Colorado Department
of Public Health
and Environment

Re: Colorado Radioactive Materials License # 660-01 for the Umetco Maybell Title II Site- Response to a Letter Received August 21, 2006 Regarding NRC's Response to Our Draft CRR Submittal dated March 31, 2006

I Geotechnical Stability

FIGURE 1

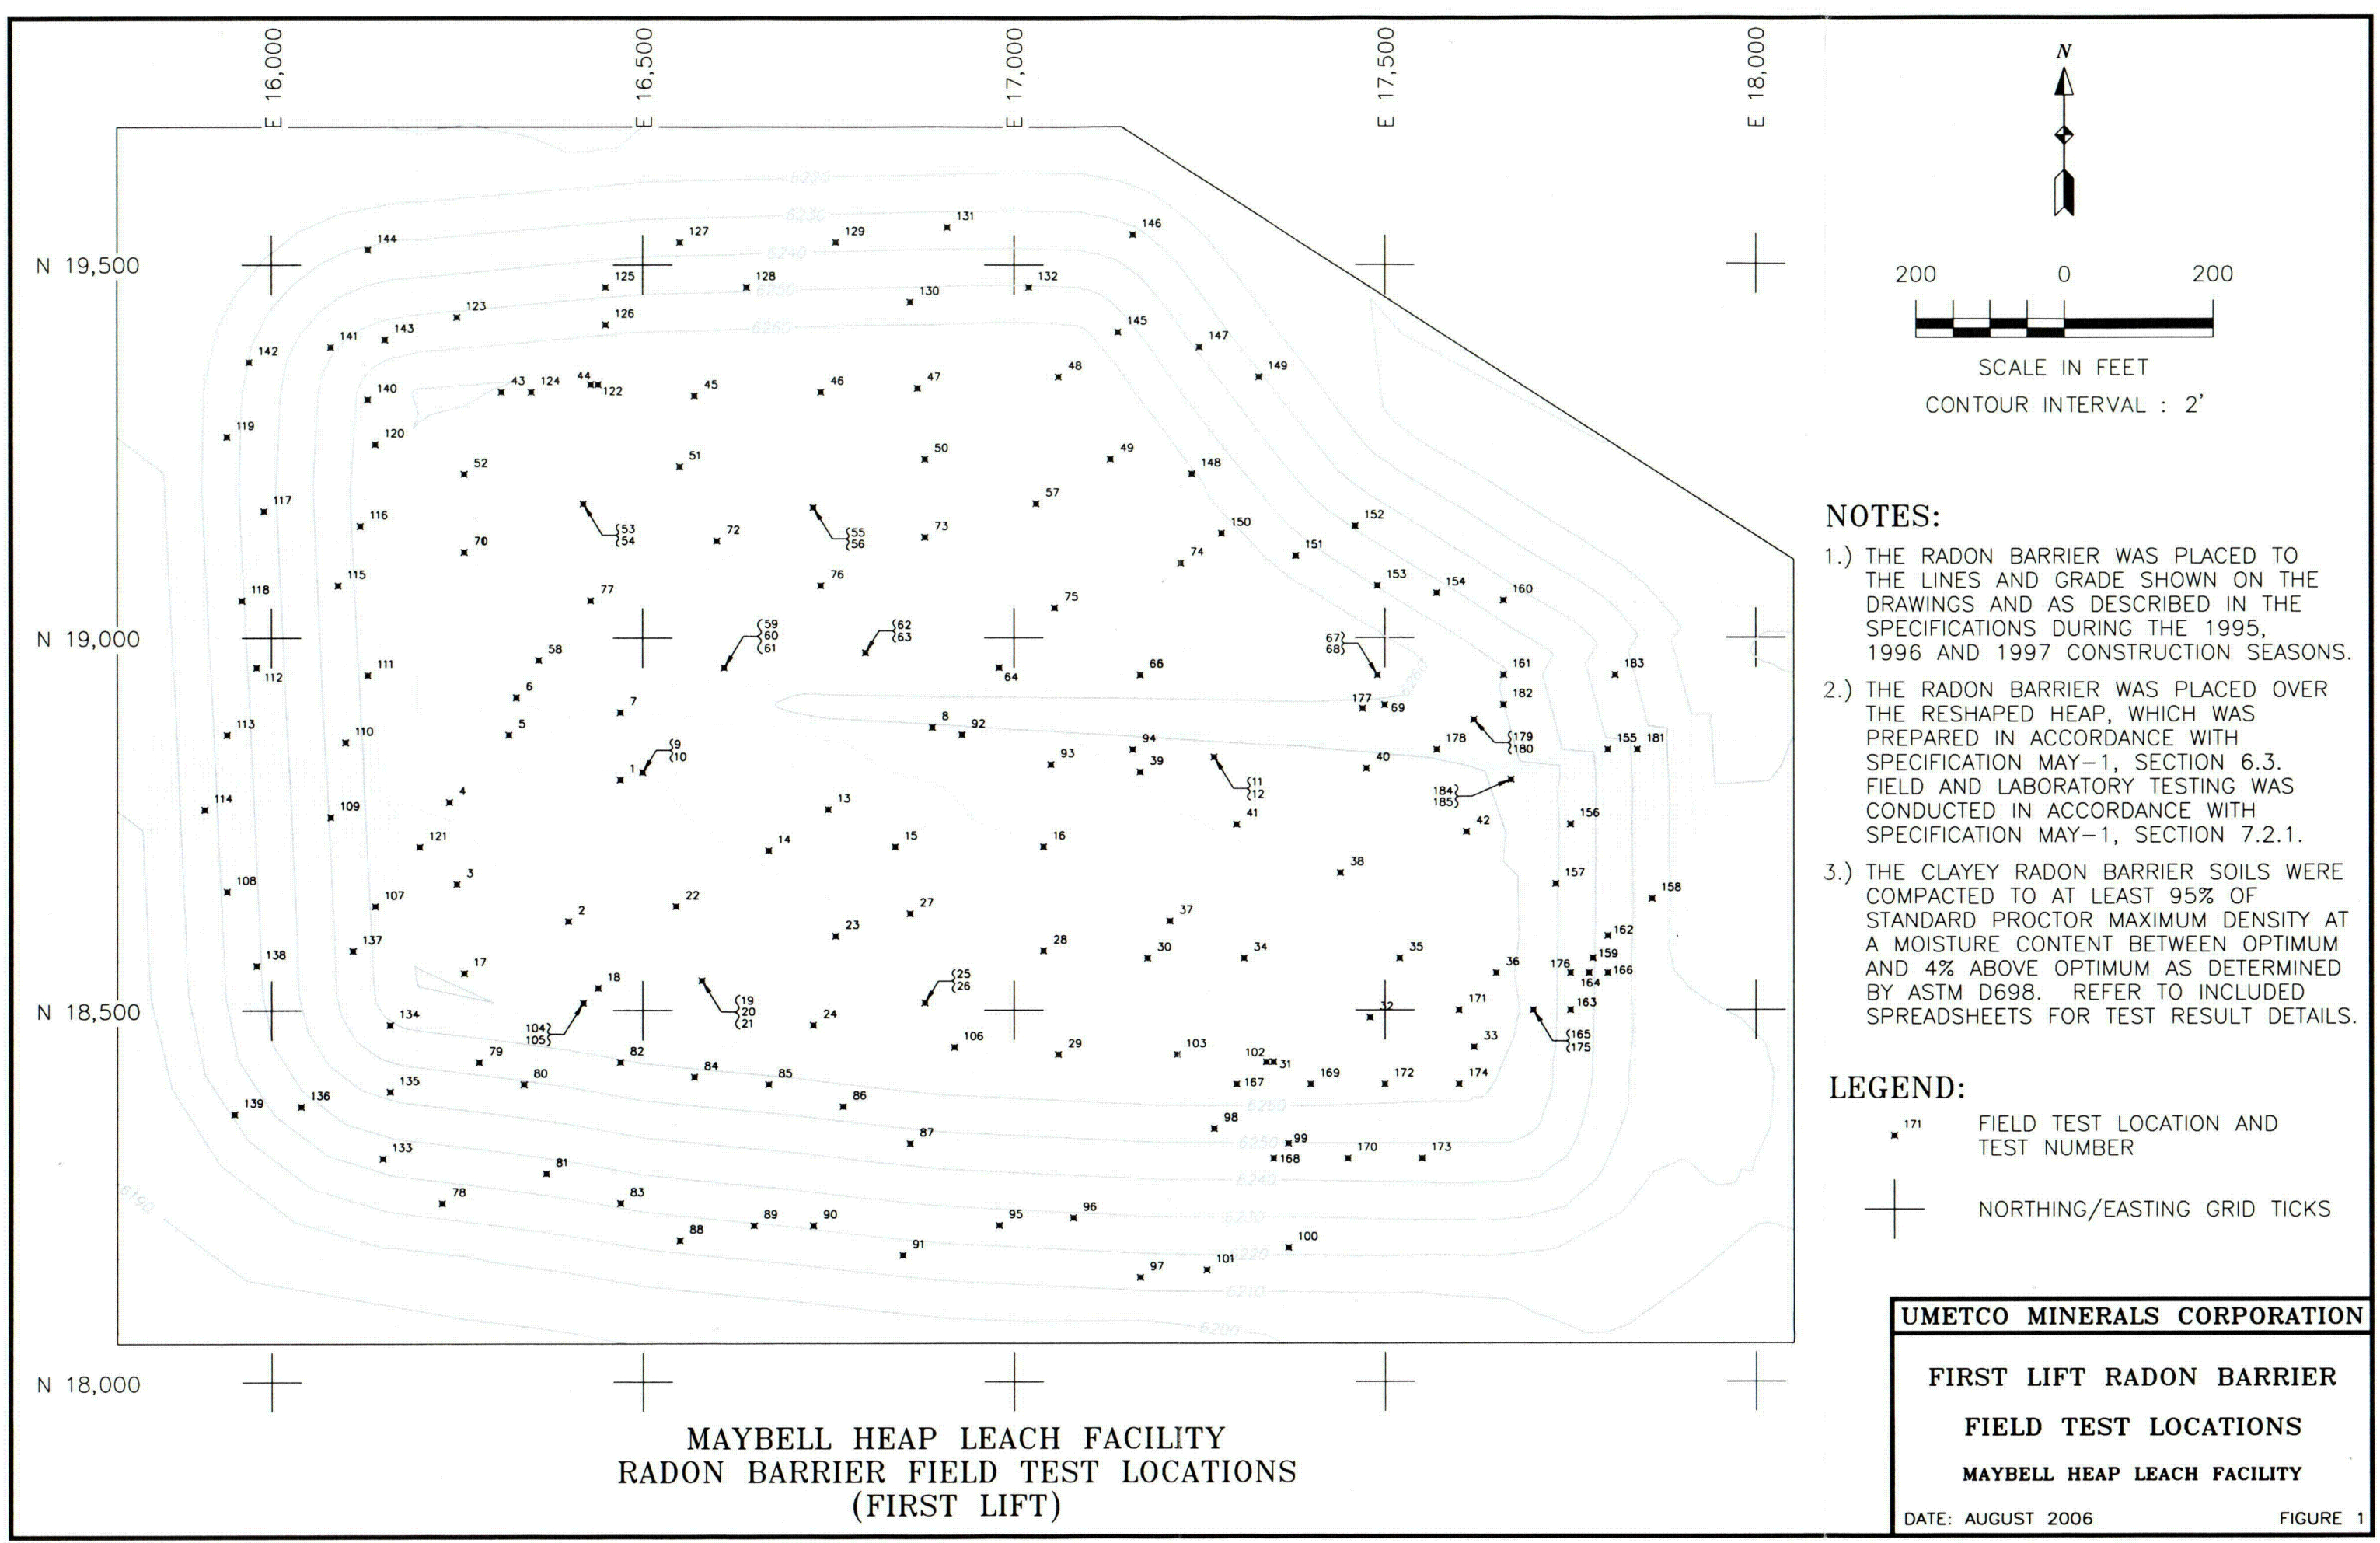
| Comment | Section of CRR | Comment | Resolution |
|----------------|---|---|--|
| 1 | Page 20, Tables 2.1.5-3 and 2.1.5-4 | Graphical results of density test locations should be provided. | Field test locations and results are given in Attachment 1. Figures 1 through 3 show the locations of radon barrier tests on the Heap Leach Repository by lift. Figures 4 through 7 show the location of the frost barrier tests on the Heap Leach Repository by lift. Figures 8 and 9 show the locations of the radon barrier and frost barrier tests on the Ancillary Cell, respectively. Separate spreadsheets of the test results are provided to accompany each figure. |
